U.S. Department of Energy  
ENERGY STAR Program

Windows, Doors, and Skylights  
Revised Draft Criteria and Report

Published: March 11, 2009

Figure 1: Revised Draft ENERGY STAR Climate Zone Map

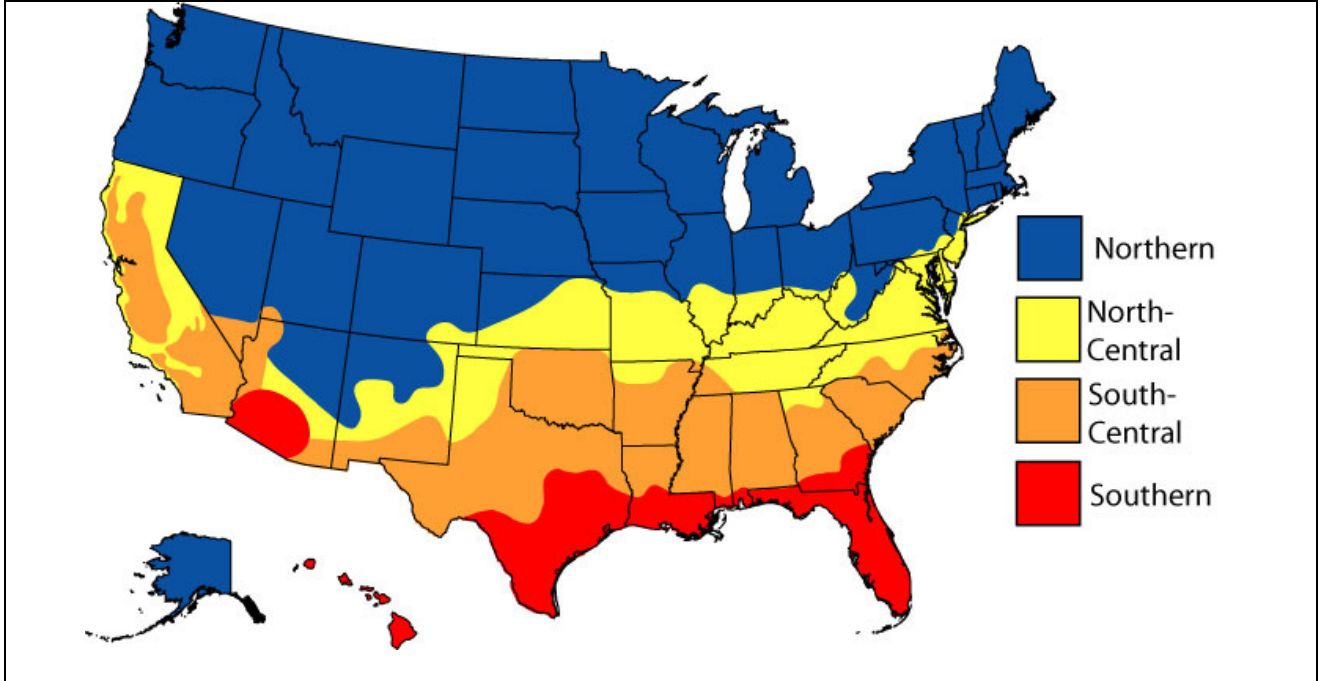
Stakeholders raised several concerns about the map proposed in the *Draft Criteria and Analysis* and suggested solutions:

- The criteria levels proposed in Zones ES5 and ES4 are too similar to warrant separate zones, and additional zones complicate the current four-zone system. The Window and Door Manufacturers Association (WDMA) and the American Architectural Manufacturers Association (AAMA) jointly proposed an alternative map that combined the two zones and ES5a, among other changes.
- The establishment of a “by-request” zone in the Pacific Northwest sets a precedent for the creation of additional zones based on stakeholder request and the introduction of too much complexity for the consumer.
- The use of numeric nomenclature for the climate zones causes confusion with IECC zone numbers. Stakeholders suggested returning to the geographic designations used in the current ENERGY STAR map.

Responding to these stakeholder comments, DOE made the following changes to the ENERGY STAR climate zone map (see Figure 1):

- Combined the proposed Zones ES5 and ES4 into one zone because both zones can benefit from the same criteria;
- Re-integrated Zone ES5a into the standard Northern Zone, as the 0.30 U-factor option now meets the incentive requirements of the NW utilities; and
- Returned zone nomenclature to geographic designations to avoid confusion with IECC zone numbers.
